Clause 104 Cleanup

GITESH BHAGWAT, ANDY GARDNER, HEATH STEWART

SANTA BARBARA DESIGN CENTER

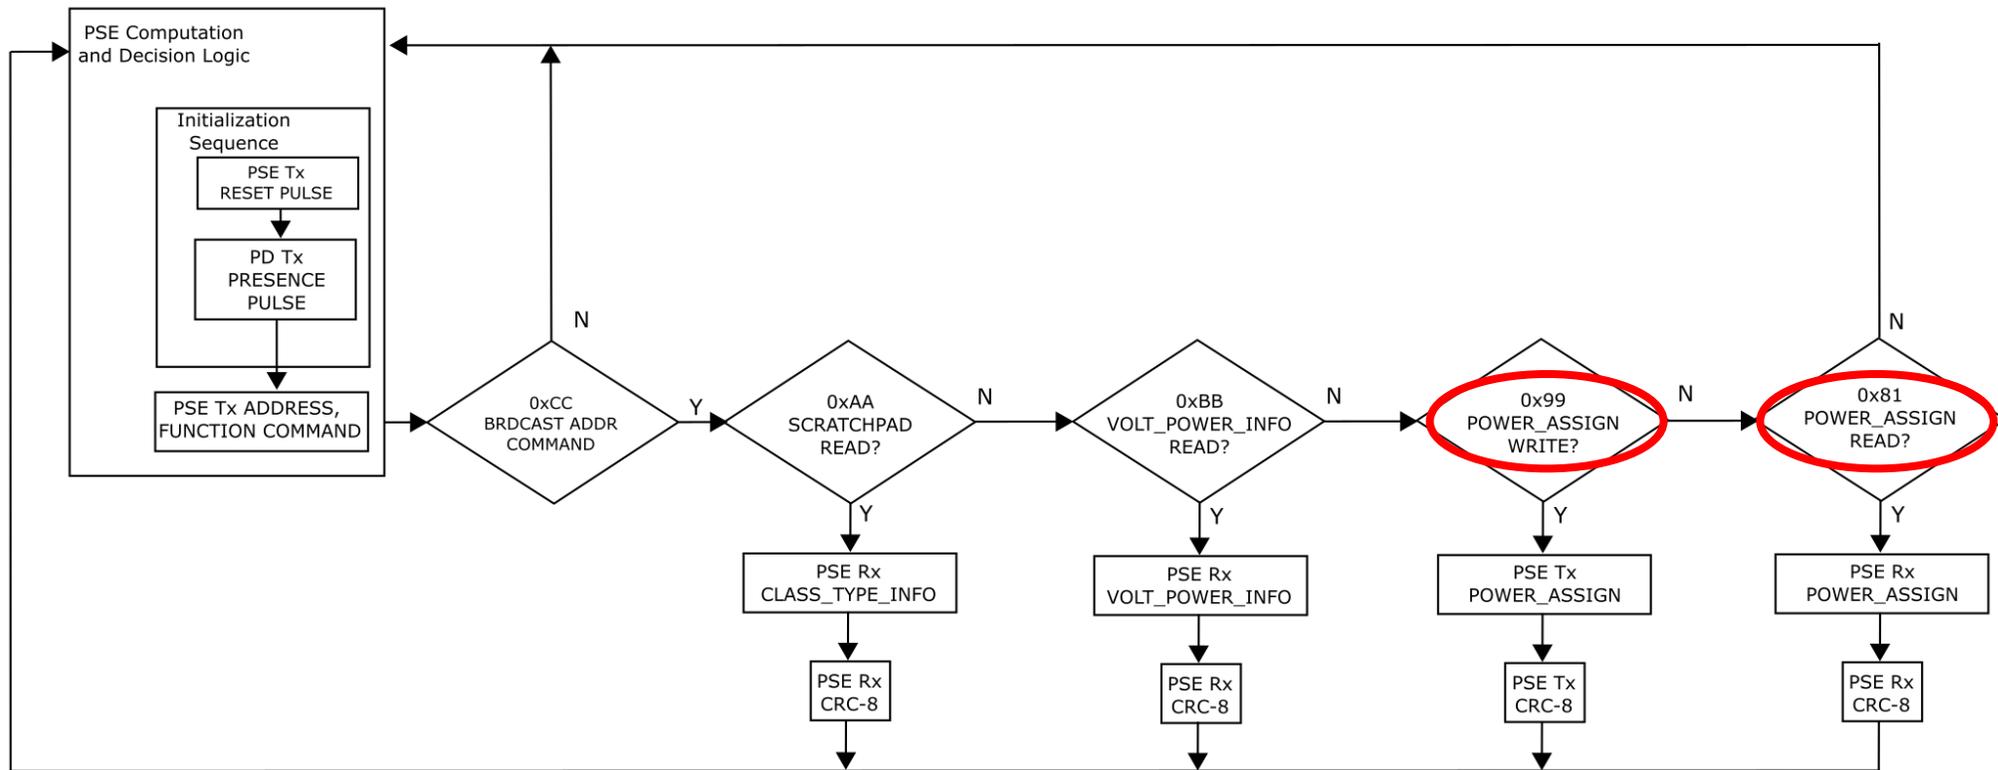
Rename in SCCP Flowchart

- ▶ Flowchart with modified command names
- ▶ Replace Figure 104-13 with the one shown below (name changes):
